Product Change Notification / SYST-07HTCT839

ERRATA - dsPIC33CH128MP508 Family Silicon Errata and Datasheet Clarification

dsPIC33CH128MP508 Family Silicon Errata and Data Sheet Clarification

FIGURE 1: I/O RAMP

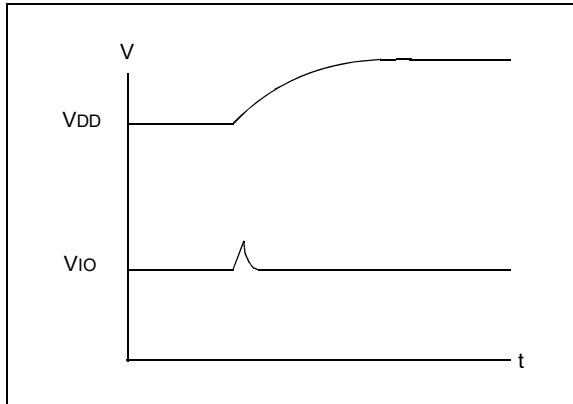
During a fast device power-up, when the VDD ramp is less than 4 mS, the I/O pins may drive up to 100 μ A current for a duration of up to 10 μ S (Figure 1).

1. Slow down the VDD ramp time (greater than 4 mS for VDD to ramp 0V to 3.3V).
2. Ensure the circuitry that is connected to the pins can endure this pulse.

High-voltage applications with complementary switches should power the high-voltage 200 μ Sec later than powering the dsPIC[®] device to avoid the current shoot-through. This behavior is specific to each device and not affected by aging.

FIGURE 2-2: SUGGESTED PLACEMENT OF THE OSCILLATOR CIRCUIT

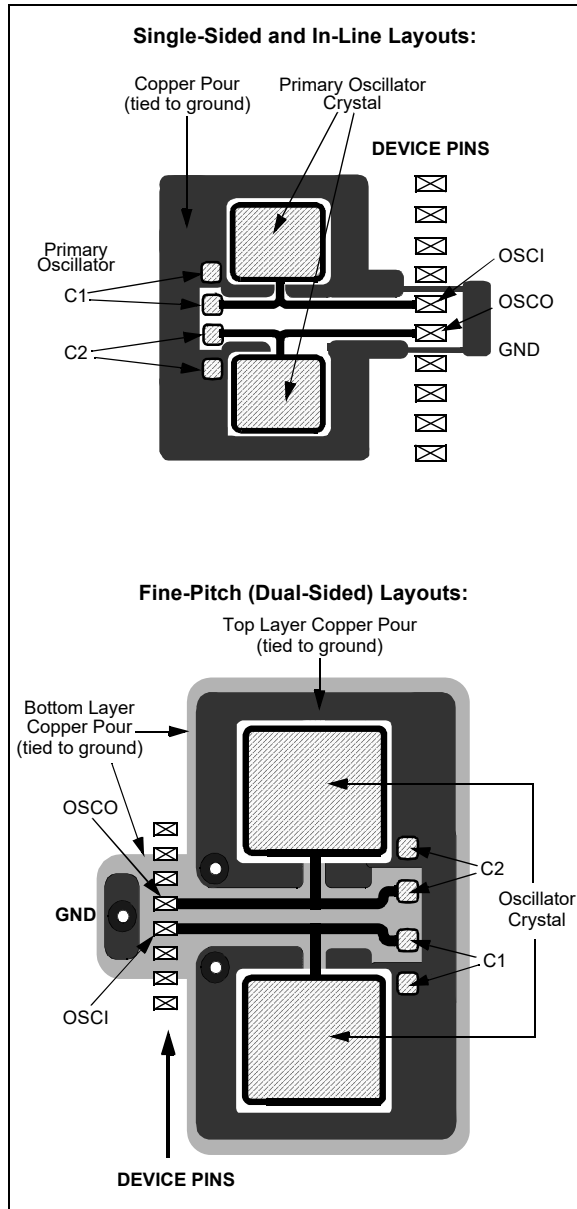
Additional information is added to [Section 2.5 “External Oscillator Pins”](#) and [Section 2.6 “External Oscillator Layout Guidance”](#) is added.

Use best practices during PCB layout to ensure robust start-up and operation. The oscillator circuit should be placed on the same side of the board as the device. Also, place the oscillator circuit close to the respective oscillator pins, not exceeding one-half inch (12 mm) distance between them. The load capacitors should be placed next to the oscillator itself, on the same side of the board. Use a grounded copper pour around the oscillator circuit to isolate it from surrounding circuits. The grounded copper pour should be routed directly to the MCU ground. Do not run any signal traces or power traces inside the ground pour. If using a two-sided board, avoid any traces on the other side of the board where the crystal is placed. Suggested layouts are shown in [Figure 2-2](#). With fine-pitch packages, it is not always possible to completely surround the pins and components. A suitable solution is to tie the broken guard sections to a mirrored ground layer. In all cases, the guard trace(s) must be returned to ground.

FIGURE: ADC ANALOG INPUT MODEL

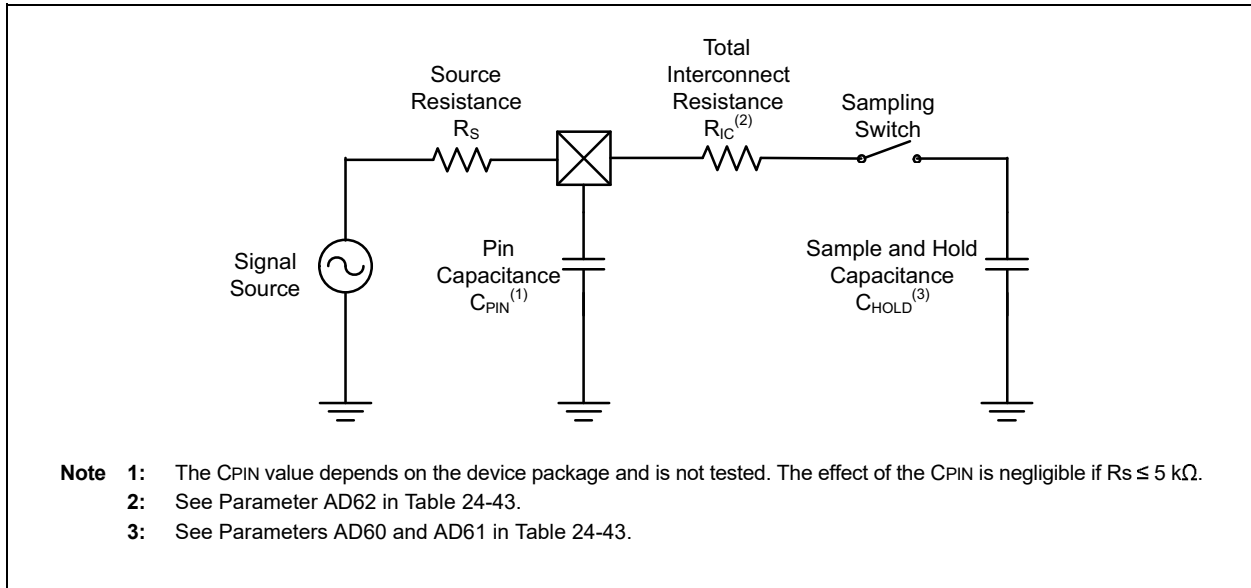
The following **Sampling Time Requirements** section has been added to both **Section 3.9 “High-Speed, 12-Bit Analog-to-Digital Converter (Main Core ADC)”** and **Section 4.7 “High-Speed, 12-Bit Analog-to-Digital Converter (Secondary Core ADC)”**.

The total acquisition time for the Analog-to-Digital conversion is a function of the Holding Capacitor (C_{HOLD}) charge time. For the ADC module to meet its specified accuracy, the Holding Capacitor (C_{HOLD}) must be allowed to fully charge to the voltage level on the analog input pin. The Signal Source Impedance (R_S) and the Interconnect Impedance (R_{IC}) combine to affect the time required to charge the C_{HOLD} . The total resistance ($R_S + R_{IC}$) must therefore, be small enough to fully charge the Holding Capacitor within the selected sample time.
